Report of the Committee on**Automatic Sprinkler Systems (AUT-AAC)****Technical Correlating Committee****John G. O'Neill, Chair**

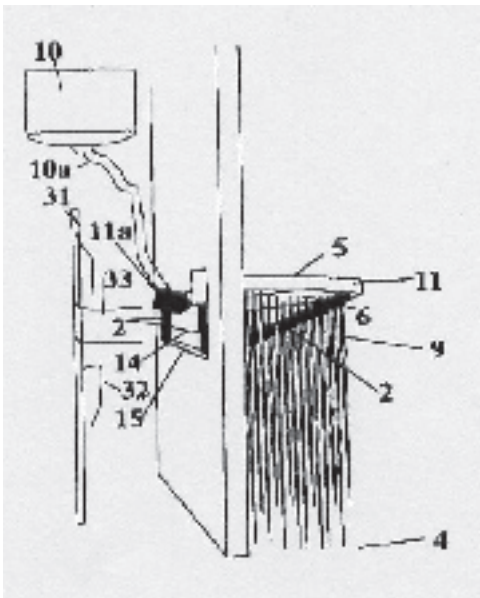
SUBSTANTIATION: Included with the drawing of a liquid nitrogen dispensing unit is justification of including liquid nitrogen with water fire control. The reasons this, rather than halon-type chemical fire control categories, is where liquid nitrogen methods should be included in the NFPA Codes and Standards.

Here is a drawing of a unit system where 10 indicates a reservoir, 10a the transfer tubing, 11 the dispenser, and 14 the means to affix the dispenser to the window insert or wall. When the Liquid Nitrogen is dispersed it is liquid 2 and as it evaporates it is gaseous 4.

COMMITTEE MEETING ACTION: Reject**COMMITTEE STATEMENT:** Outside the scope of NFPA 13R.**NUMBER ELIGIBLE TO VOTE: 27****BALLOT RESULTS:** Affirmative: 26**BALLOT NOT RETURNED: 1 BAKER**13R-6 Log #CP3 AUT-RSS
(1.1)**Final Action: Accept****SUBMITTER:** Technical Committee on Residential Sprinkler Systems**RECOMMENDATION:** Add additional text to the Scope as follows:

Figure 6.7.1.3.2.2 Measuring “S” Dimension.

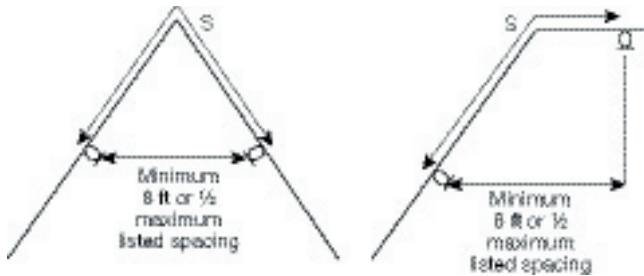
6.7.1.3.2.2.1 Where the ceiling is sloped the maximum “S” dimension shall be measured along the slope of the ceiling to the next sprinkler as shown in Figure 6.7.1.3.2.2 on the following page.

6.7.1.3.2.2.2 The sprinklers shall maintain a minimum of 8 ft or 1/2 the maximum listed spacing, whichever is greater, measured in the plan view from one sprinkler to another as shown in Figure 6.7.1.3.2.2.

SUBSTANTIATION: The standard does not offer a clear perspective on how to measure the spacing along a sloped ceiling. This proposal offers guidance to the end user clarifying the intent to measure along the slope.

Figure 6.7.1.3.2.1.2. Measuring “S” Dimension.

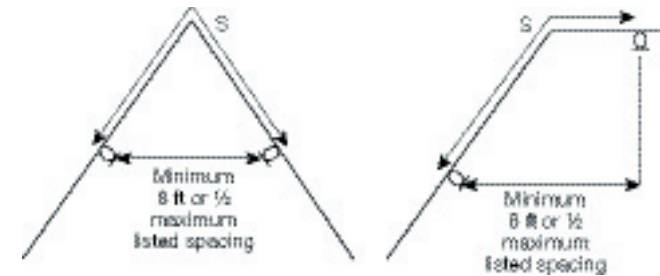
6.7.1.3.2.1.1 Where the ceiling is sloped the maximum “S” dimension shall be measured along the slope of the ceiling to the next sprinkler as shown in Figure 8.1.3.2.2.

6.7.1.3.2.1.2 The sprinklers shall maintain the minimum listed spacing, but no less than 8 feet, measured in the plan view from one sprinkler to another as shown in Figure 6.7.1.3.2.1.2

COMMITTEE STATEMENT: The committee agreed with the submitter but wanted to further clarify the 8 ft minimum.
